# METROPOLITAN GOVERNMENT OF NASHVILLE AND DAVIDSON COUNTY

## STAFF RECOMMENDATION November 15, 2017

**Application:** New construction- addition and detached accessory dwelling unit; Partial demolition

**Description of Project:** Application is to construct rear and side additions, to alter an existing side porch and windows, and to reduce the separation between the addition and an approved detached accessory dwelling unit from twenty feet (20') to six feet (6').

Figure 3 & 4 show the enclosed rear porch that is to be demolished.

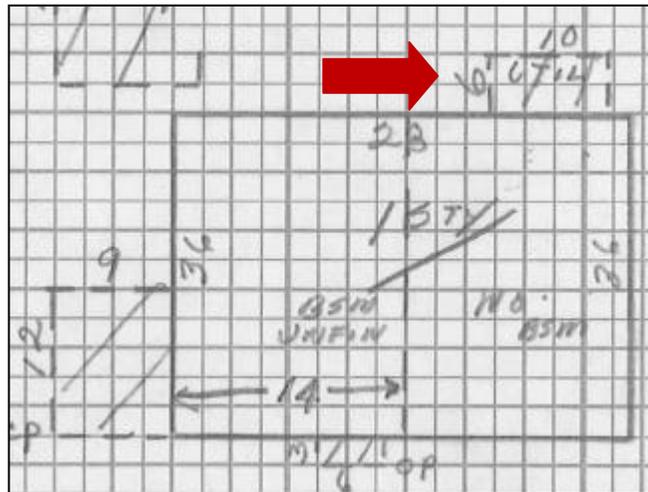
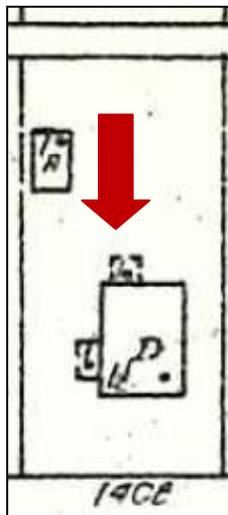
The applicant proposes to demolish an existing enclosed rear porch (Figures 3 – 4). The addition was likely enclosed sometime after 1968 as both the 1957 Sanborn Map (Figure 5) and the 1968 Property Assessor card indicate an open porch on the rear (Figure 6). Staff finds that the addition's date of construction, location at the rear of the house, roof form, materials, and design do not contribute to the historic character of 1408 Paris Avenue or to the Belmont-Hillsboro Neighborhood Conservation Zoning Overlay; therefore, demolition is appropriate.

Figure 7 (left) shows the paired windows that are to be demolished. Figure 8 (above) shows the sliding glass door proposed for that location.

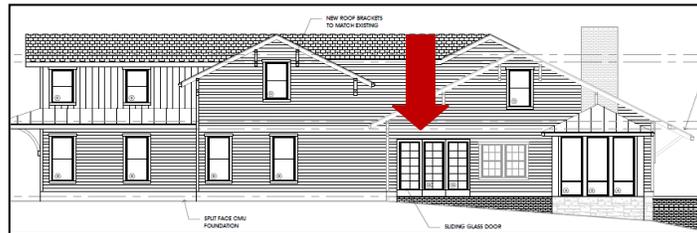
The plan proposes to replace the paired windows on the left side façade near the rear of the historic house with a sliding glass door (Figures 7 – 8), similar to the one disapproved at the prior commission meeting. Staff finds that the proposed door opening is a type of opening that is more often found on rear façades and is too large for the proposed

location. While windows are considered character defining features of historic homes, the Commission has permitted the alteration of windows on the side façade of the house beyond the midpoint where the proposed openings meet the proportion and rhythm of openings that are typical of historic homes. In this case, the proposed window alteration is beyond the midpoint of the historic house but does not meet the proportion and rhythm of openings that are typical on side façades of historic homes.

Staff recommends disapproval of the alteration to the windows on the left side façade, finding that it does not meet Section V.1 for appropriate demolition and meet Section V.2 for inappropriate demolition.

**3** Rear Elevation - DADU  
SCALE: 1/8" = 1'-0"

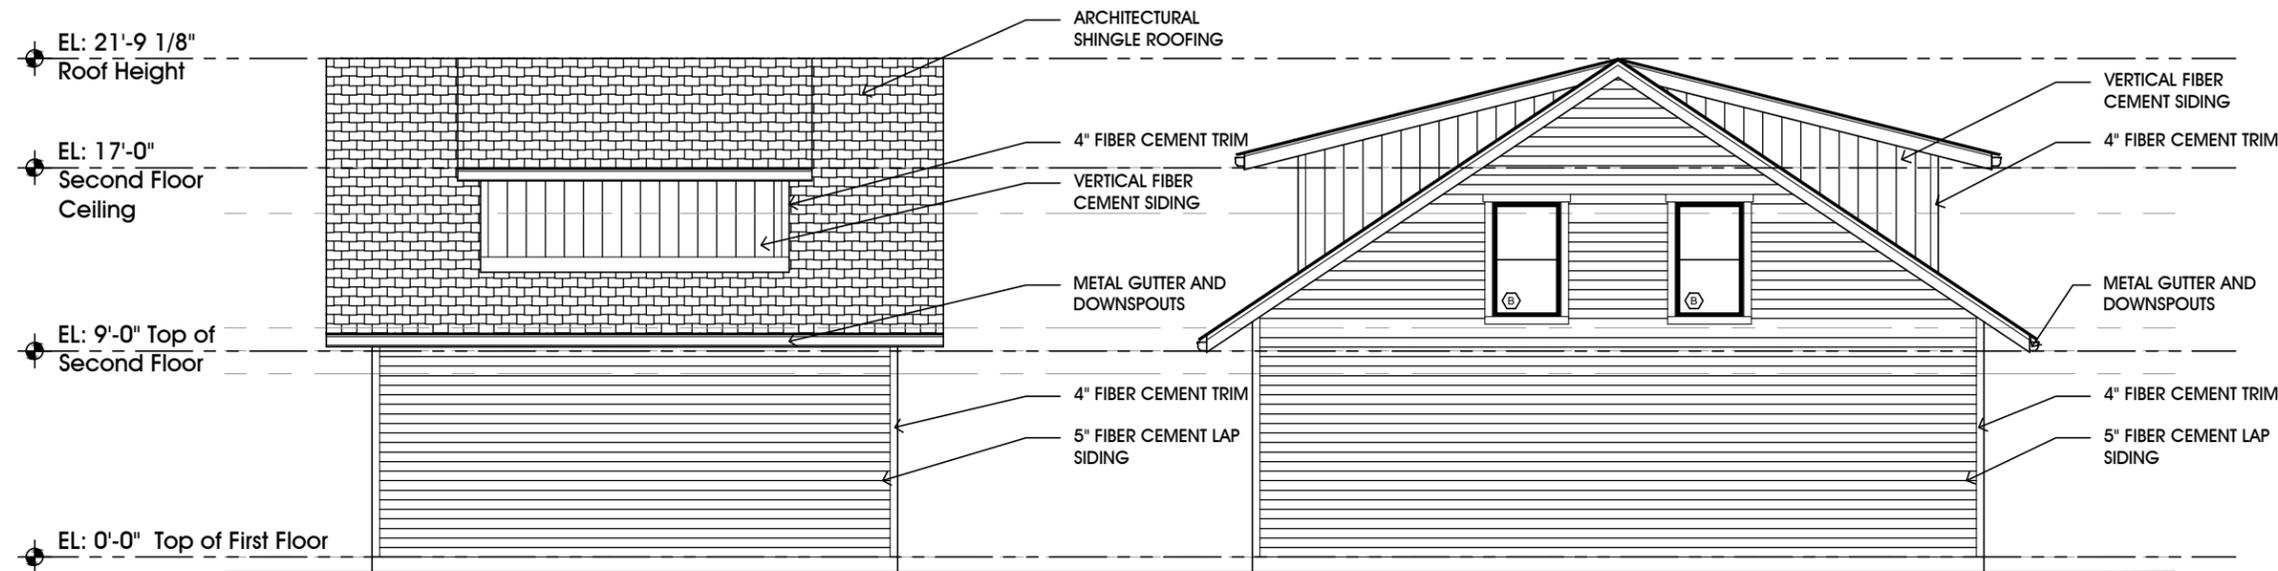
The form and slopes of the roof are similar to historic outbuilding. However, the dormer on the rear elevation exceeds 50% of the roof plane. With the condition that the dormer on the rear elevation not cover more than 50% of the roof plane, staff finds that the project could meet Section II.B.i.1 of the design guidelines and section 17.16.030.G.8 of the ordinance.

1. The distance between the house and DADU shall be increased to ten feet (10’);
2. The dormer on the rear elevation of the DADU shall not cover more than 50% of the roof plane;
